**REF: PA 2022/3796 - Proposal to demolish 2 detached houses to construct 2 blocks comprising 33 flats at 16 – 18 Oatlands Drive, Weybridge**

This document contains our final responses to the late amendments by the developer and the Planning Officer's latest response to these and associated residents' comments.

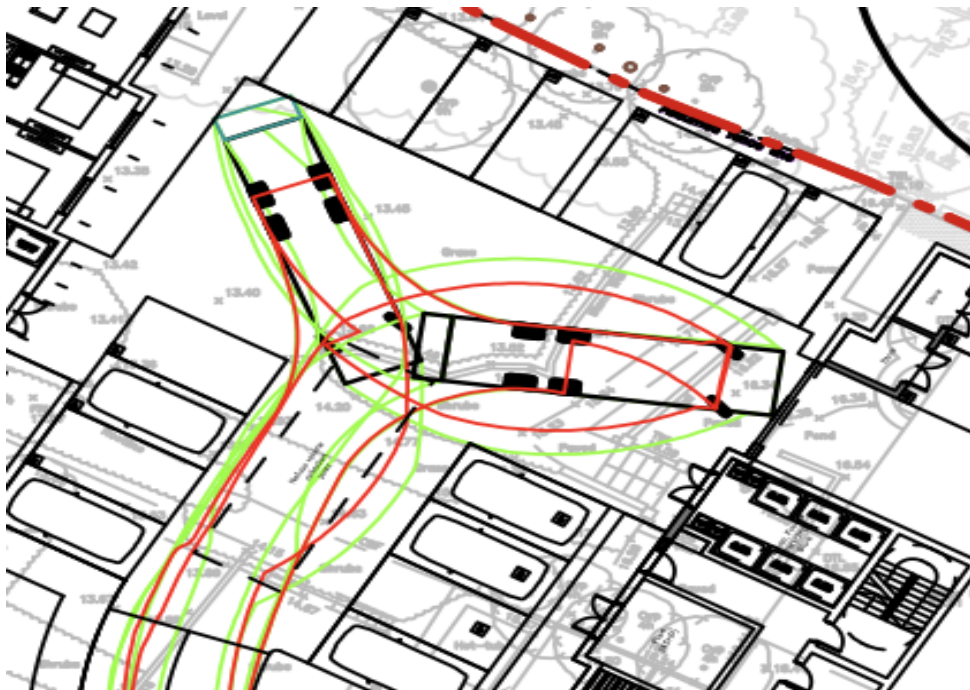
Also, it appears to us that the refuse trucks would have to reverse almost into the walls of the buildings to turn around (see attached drawing). Surely given how tight this is JWS would have to review the swept path analysis themselves to confirm they have no objection.
